May 31, 2016

Re: FirstLight Hydro Generating Company, Turners Falls Hydroelectric Project (FERC No. 1889) and Northfield Mountain Pumped Storage Project (FERC No. 2485).
Response to Stakeholder Requests for Study Modifications and/or New Studies Based on the Study Report and Meeting Summary

Path: W:\gis\studies\3_6_5\maps\ownership.mxd

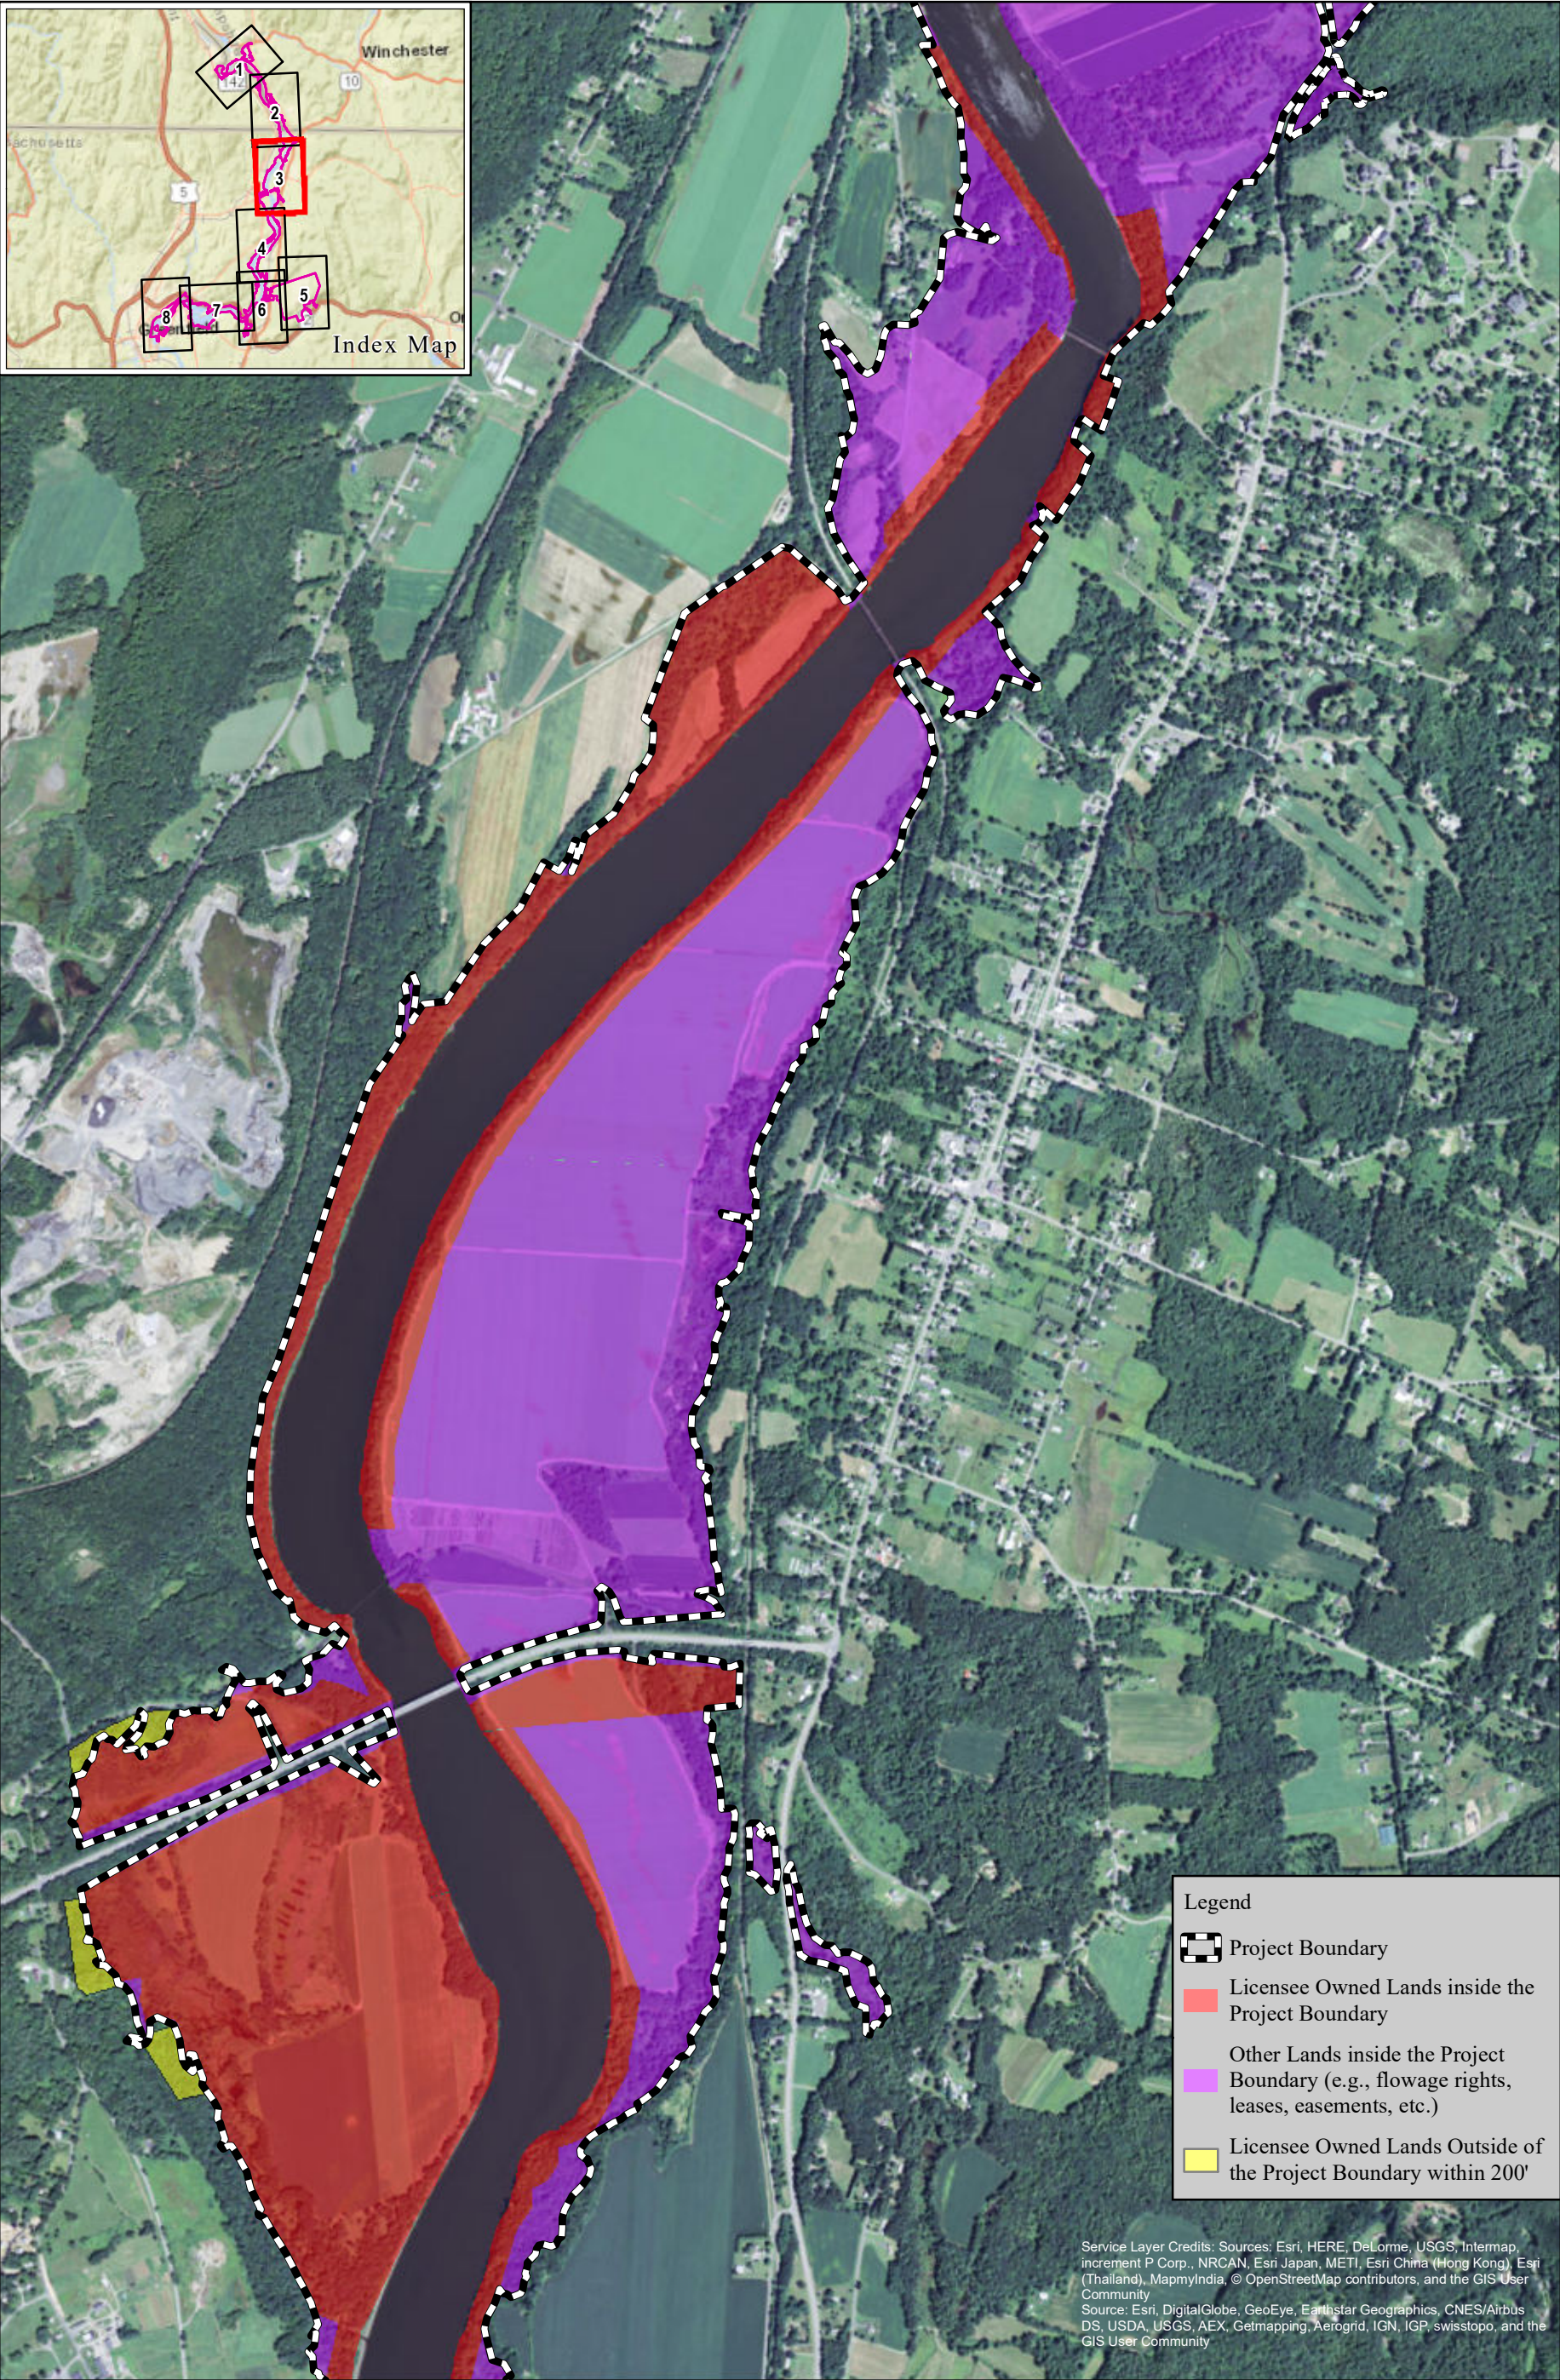
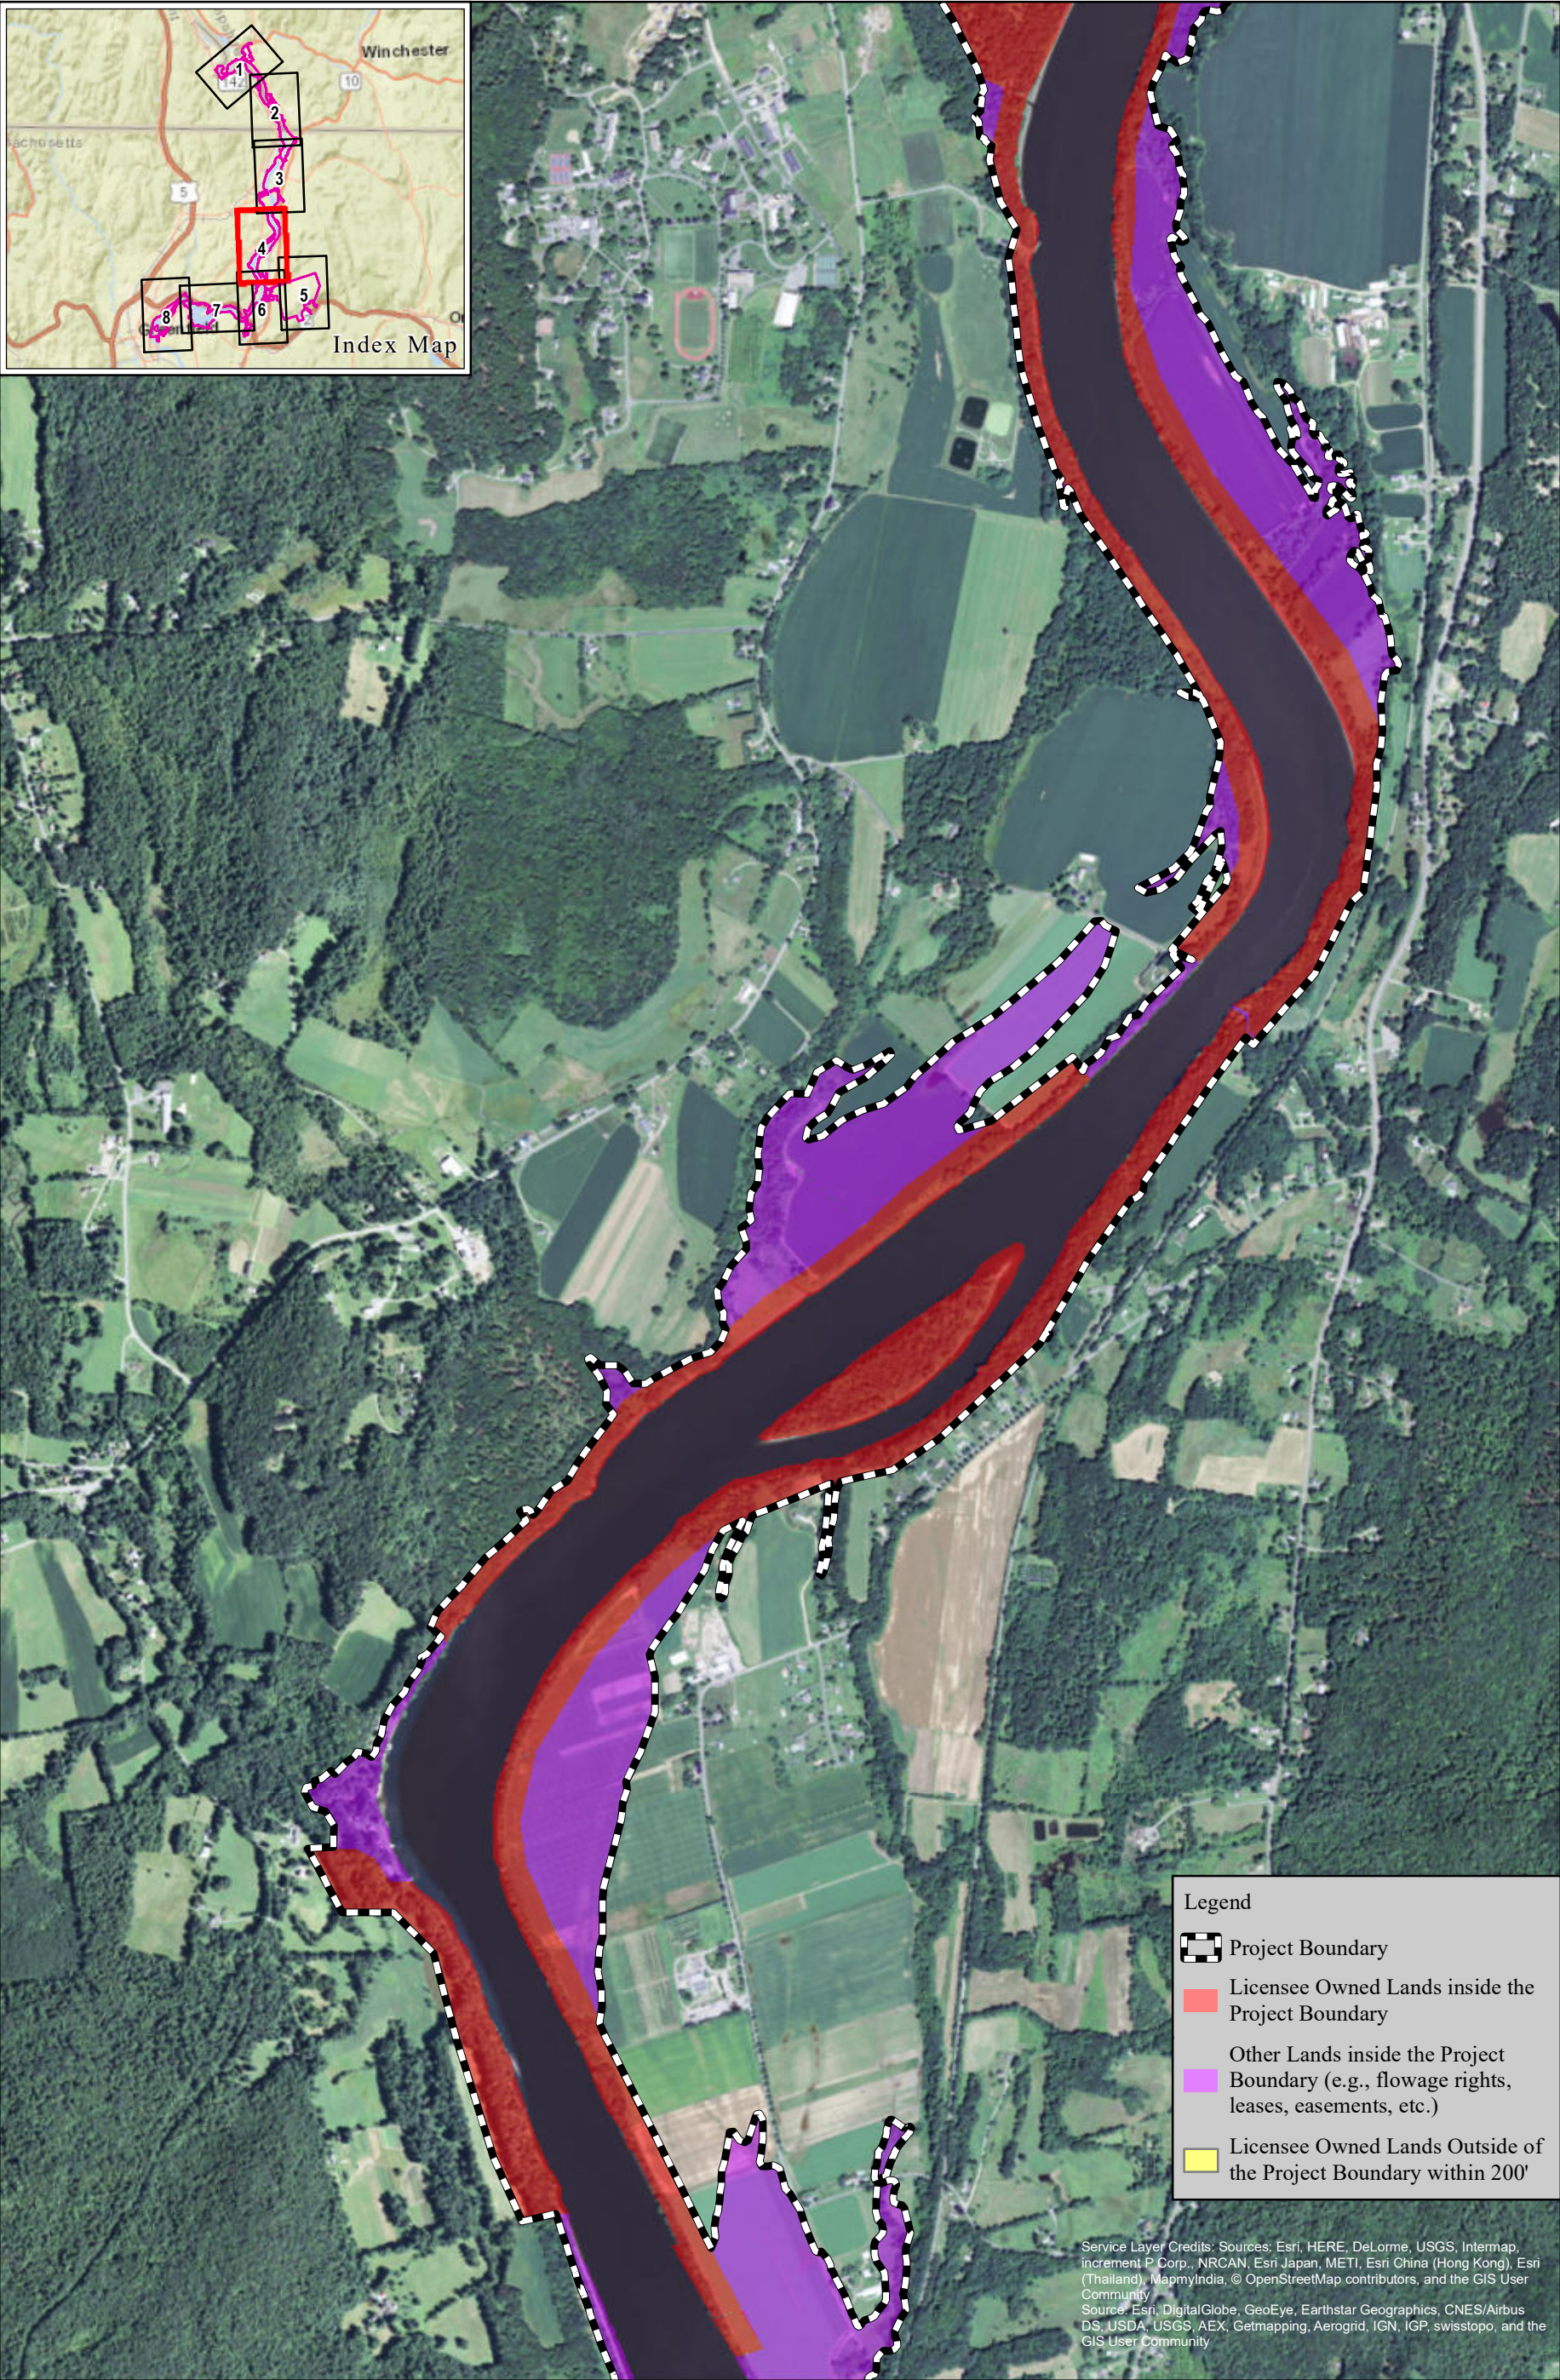
Commenter	Comment	Responses
CRWC-1	The report does not identify ownership and other controls such as FirstLight’s flowage rights within the Project boundaries. FirstLight does not own all of the lands within the project boundaries. FirstLight ownership of lands within 200 feet of the Project boundaries is identified in Figure 4.4-1, but nothing indicates ownership within the boundaries. CRWC requests that FirstLight provide information on land it has ownership or any other control over, and the land use associated with those lands, in an addendum to Study 3.6.5.	FL has updated the maps that comprise Figure 4.4-1 in the 3.6.5 study report to show FL land ownership within the project boundary. See Study 3.6.5 Attachment A , Figure 4.4-1. The lands owned by FL shown are fee-ownership. The figures also show other lands within the Project boundary (e.g., flowage rights, easements, leases, etc.). The land uses associated with all lands within the Project boundary are provided in the 3.6.5 study report. An addendum to the 3.6.5 study report is not necessary.
